ORIGINATION FORM

Proposed Revisions to a Standard Plans Index
(Please provide all information – Incomplete forms will be returned)

Index Number: 455-031
Sheet Number (s): 1
Index Title: 30" Square Prestressed Concrete Pile - High
Moment Capacity

INDEX	SHEET
455-031	1 of 1

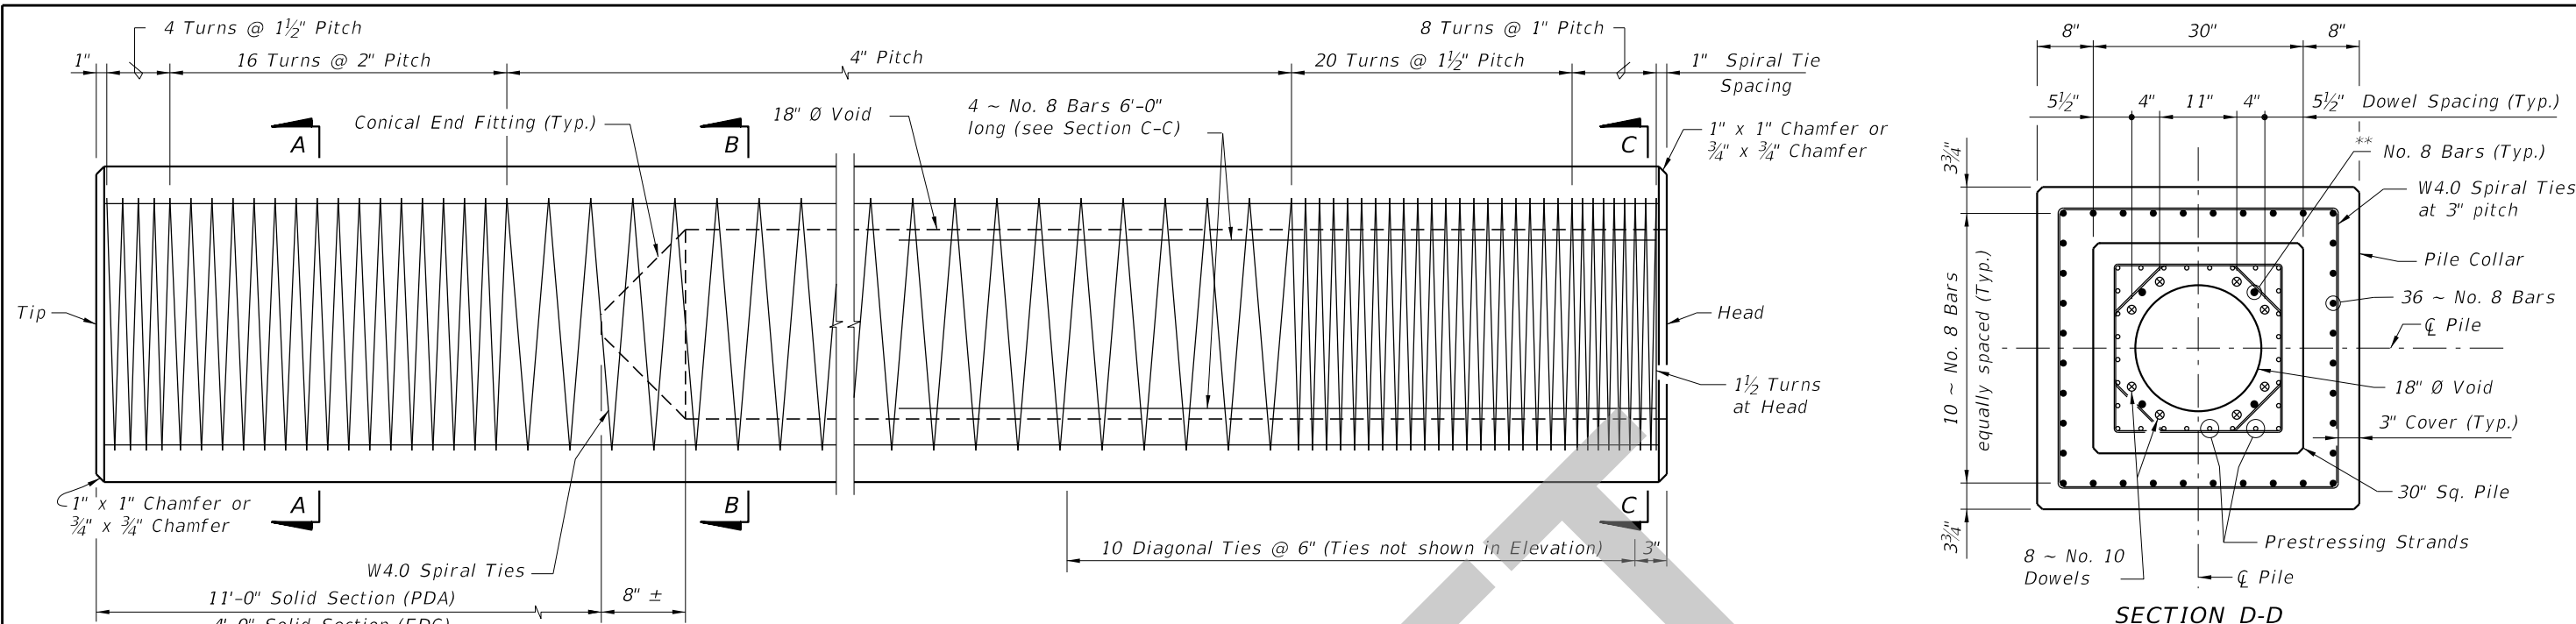
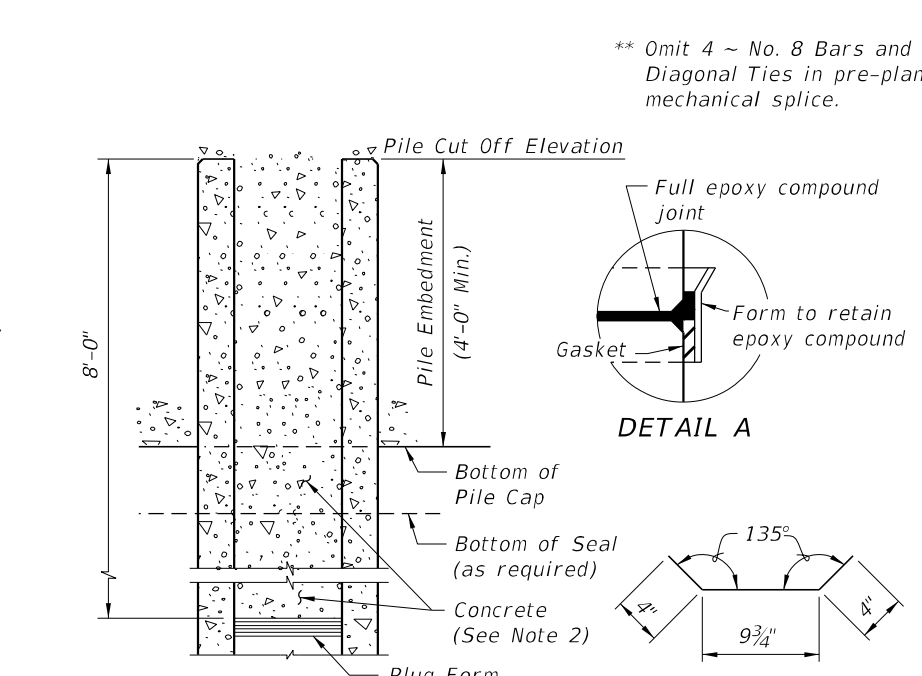
Added void length dimension for EDC

Double dimensioned void length for PDA & EDC

11'-0" Solid Section (PDA)
30'-0" Solid Section (EDC)
